Reissue of
Patent No.: 5,718,112 : Issued: February 17, 1998

For: Method and Apparatus for the
Destruction of Volatile Organic
Compounds

PRELIMINARY AMENDMENT UNDER 37 C.F.R. § 1.173(b)

FIG. 5

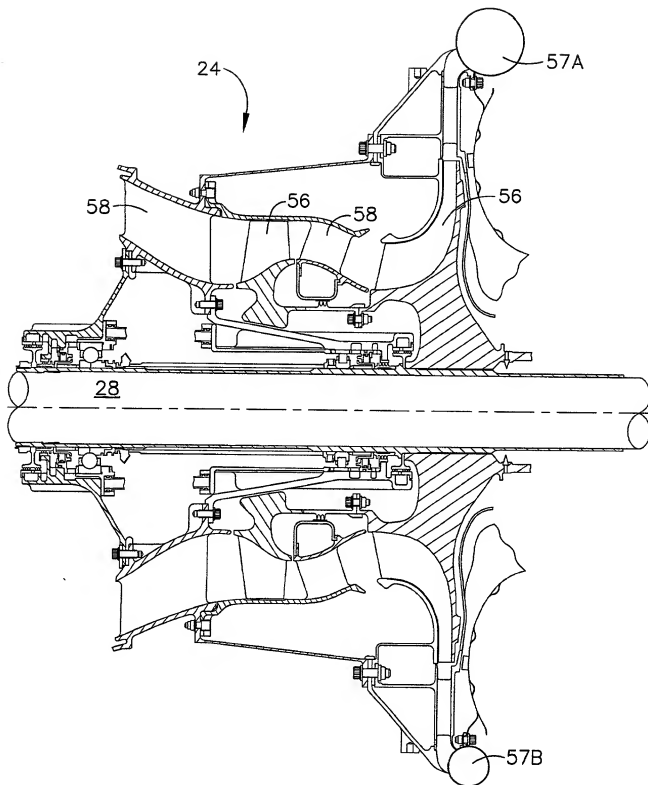
Please cancel Figure 5 in the previously issued patent.

Formal drawings are submitted herewith, in addition to a proposed drawing correction to Figure 5.

A new formal drawing to replace Figure 5 has been submitted. The incorrect Figure 5 in the previously issued patent inadvertently depicted a turbine and turbine blades rather than a compressor and compressor blades. The new Figure 5 submitted herewith depicts a compressor and compressor blades consistent with the specification in the previously issued patent. The

new Figure 5 also shows reference number 24 indicating the compressor, which is also consistent with the specification in the previously issued patent.

proposed corrected drawing
